PREVOST

WARRANTY BULLETIN

WB23-10B

DATE :	April 2023	SECTION :	23 ACCESSORIES
EXPIRATION:	April 2025		
SUBJECT :	CHANGE THE WCL BACK PLATE

FIGURE 2

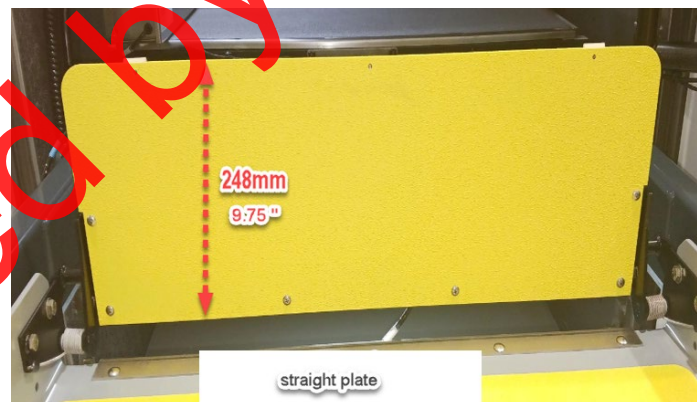
1. Open the WCL cartridge. If the yellow plate has two steps and is 280mm (11in) (Figure 1), remove it and replace it by the straight plate 863104.

2. Replace it by the straight 248mm (9.75in) plate 863104. Secure it with the 6 screws (Figure 2).
